Combined Stage 1-2 Road Safety Audit

Knowsley Business Park

Proposed S278 Highway Works

Reference: RSC/EB/MC/24128

3.1. Problem

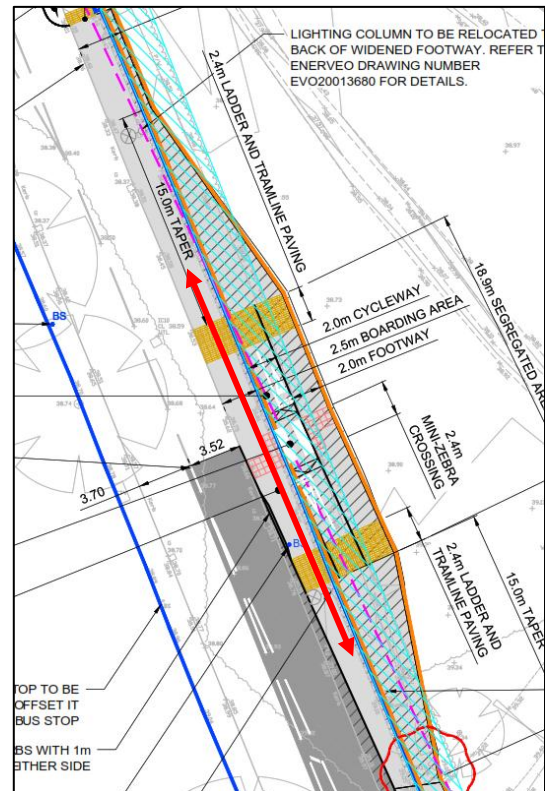
Location: Ormskirk Road

Summary: Lack of suitable linkage to surrounding shared footway/cycleway facilities may pose as a hazard for cyclists leading to rider injury.

In the vicinity of the development site, there is a dual use footway/cycleway along the southern side of the A580 with a toucan crossing facility across Ormskirk Road arm of the traffic signal junction. There is also a dual use footway/cycleway route along the northern side of the A580 into Coopers Lane.

The proposal includes for a section of shared footway/cycleway along the eastern side of Ormskirk Road, however the northern end of the proposed route does not tie in with the existing dual use footway/cycleway route along the A580 leaving a missing section of approximately 80m and the opportunity to use the controlled crossing facilities at the traffic signal junction.

However, the RSA Team are concerned that the proposed dual use route has been designed for cyclists travelling southbound only and has not taken into consideration how cyclists travelling northbound will return back to the carriageway and the ability to join the existing dual use facility on the A580 if they wish to do so. The lack of suitable transition back to the carriageway may lead to cyclists being hit by vehicles. Alternatively, cyclists may continue on the footway. This may lead to pedestrian to cyclist collisions leading to pedestrian injury.

It is recommended that northbound cyclists are provided with an appropriate facility to allow them to safely return to the carriageway. The cycle dismount sign should be replaced with 'cyclists rejoin carriageway' as recommended in LTN 1/20.

However, it may be appropriate to cutback the vegetation encroaching at the back of the footway and widen the existing footway within the available highway boundary to link the existing and proposed route, albeit a substandard width to minimise rider conflicts with vehicles, and / or pedestrians. It is noted that the shared use route around the radii of the traffic signal junction is less than the minimum recommended and is also further narrowed by the pedestrian guard railing.

3.2. Problem

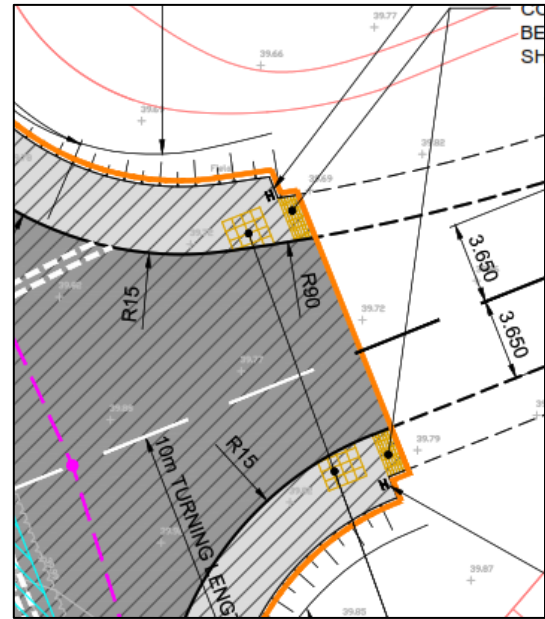
Location: Southbound bus stop

Summary: Potential conflicts between cyclists and users at the bus stop

At the bus boarder by-pass, due to the route either side of the bus boarder being shared and there being no difference in surfacing colour for the cycle section, cyclists are likely to take the direct route following the kerb edge instead of using the short section of segregated route behind the waiting area, particularly if the bus stop is not well used.

It is recommended that if a bus boarder bypass is required, the cycle lane section should be of a contrasting colour to the footway and waiting area, and cycle symbols added to guide cyclists to follow the route behind the bus stop.

3.4. Problem

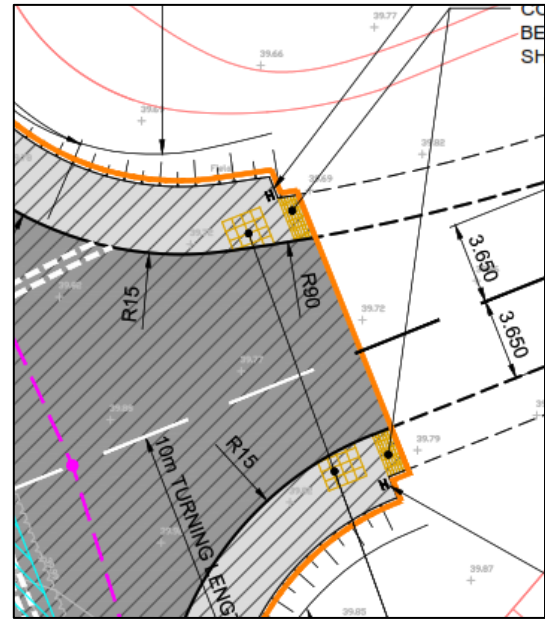
Location: Ormskirk Road

Summary: Drop at back of shared use route may be a potential slip/fall hazard for pedestrians or cyclists

At the back of some of the sections of the shared use route there is a 1 in 3 slope. The lack of a flat buffer between the shared use route and the slope may lead to slip and fall type injuries, particularly during hours of darkness if users are unable to identify the slope.

It is recommended that a flat verge area should be provided between the back of the shared use route and the start of the slope: a minimum of 0.5m should be provided or measures installed to identify the back edge of the shared use route, such as a suitable fence.

3.5. Problem

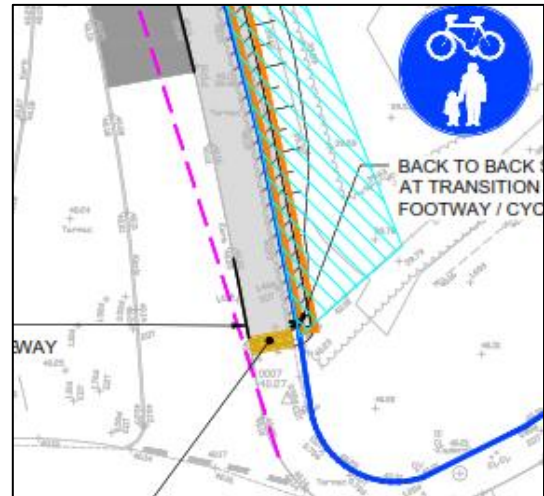
Location: Site access

Summary: Risk of cyclists being hit and injured by vehicles.

The shared footway/cycleway does not extend into the development with the facility starting/terminating at the junction.

Cyclists who rejoin the carriageway at the crossing point may be vulnerable to being hit by vehicles turning into the junction. In particular, by left turning vehicles whose drivers are likely to be concentrating on looking to the right towards vehicles turning off Ormskirk Road as they need to give way to them.

The start of the shared facility for cyclists travelling along the development access road towards Ormskirk Road may not be easily identifiable and they may end up missing the start of the facility and have to negotiate the junction instead with the potential of being hit and injured by passing vehicles.

It is recommended that the shared route on both sides of the development access road is extended further into the development away from the potential conflict with manoeuvring vehicles at the junction. Appropriately positioned lengths of dropped kerbs should be provided to allow cyclists to rejoin/leave the carriageway. The start/end of the route should be clearly identifiable. This may include the use of cycle markings (cycle logos, give way lines and arrows). The cycle dismount sign should be replaced with 'cyclists rejoin carriageway' as recommended in LTN 1/20.

3.7. Problem

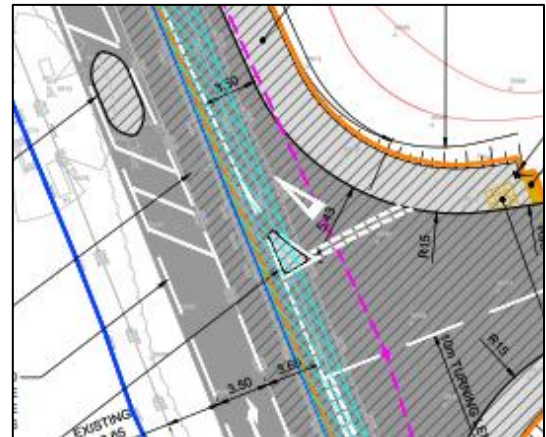
- Location: Ormskirk Road roundabout
- Summary: Risk of cyclists being hit and injured by vehicles.

There is no connectivity for cyclists travelling northbound along Ormskirk Road from the roundabout to access the shared use facility on the eastern side. The lack of connectivity may lead to cyclists remaining on the carriageway with the risk of being hit and injured by vehicles overtaking them. Cyclists turning right into the development may be particularly vulnerable when turning right into the access.

It is recommended that a suitable location to enable northbound cyclists to join the shared use route should be provided. It may be appropriate to provide a short length of shared use route on the western side and increase the size of the proposed pedestrian refuge island so that it is suitable for cyclists to use.

3.9. Problem

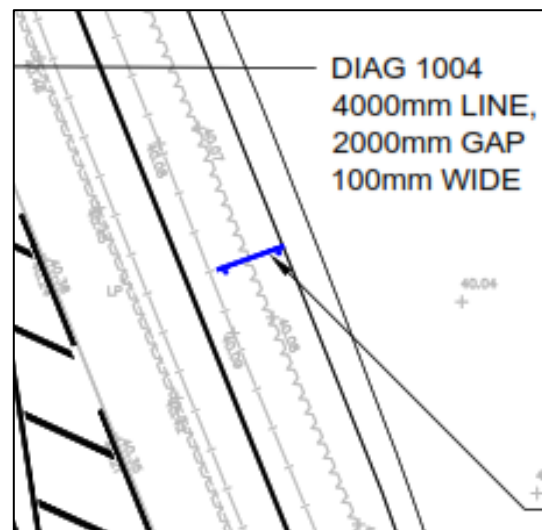
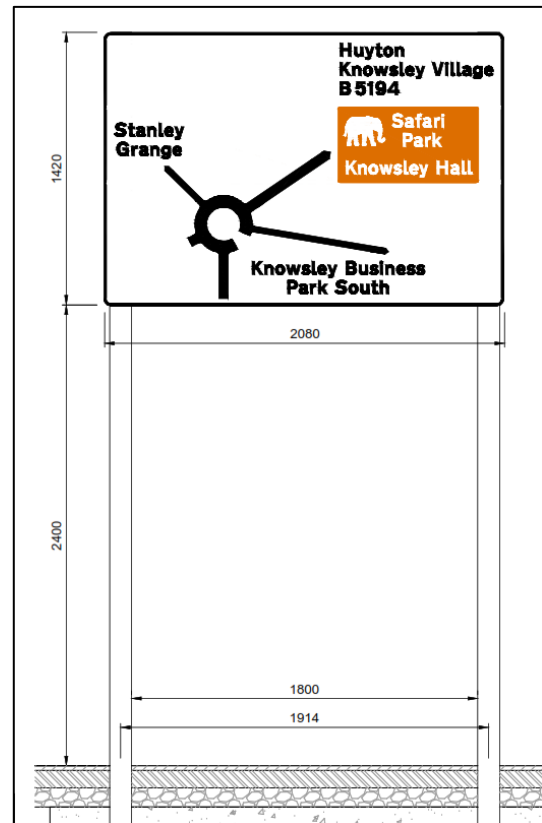
Location: Site Access

Summary: Cycle to vehicle collisions, involving vehicle overtaking manoeuvres

The traffic lane widths through the ghost island junction, passed the pedestrian refuge island and traffic island are 3.65m wide. Gaps of 3.1 to 3.9 metres are the least satisfactory from a cyclist's perspective, as a driver may perceive that the carriageway is wide enough to overtake a cyclist through the refuge/traffic island, which may result in a cyclist being squeezed and hit.

It is recommended that lane widths between 3.1m and 3.9m should be avoided, to safeguard cyclists at gaps. It is acknowledged that swept paths may require that the traffic lanes through the junction are wider than desirable for cycle safety, therefore it may be appropriate to visually narrow the lane widths by widening hatched markings.

3.10. Problem

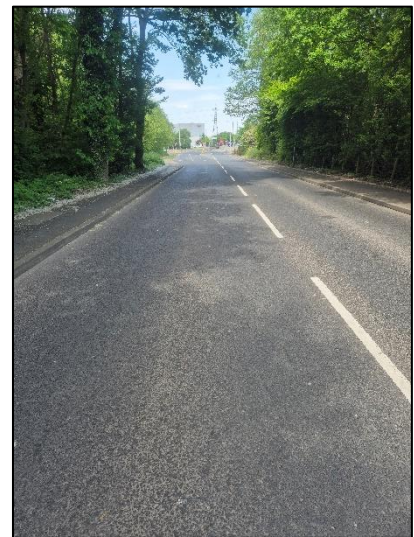
Location: Relocated directional sign

Summary: Sign posts - obstruction and a potential hazard for cyclists and pedestrians.

The spacing between the posts for the relocated directional sign will reduce the effective width of the shared use width and may pose as a hazard for users, particularly during hours of darkness.

It is recommended that the sign assembly is redesigned to prevent the sign posts obstructing the route. It is also recommended that reflective colour contrasting bands are added to the post if they are located within the route.
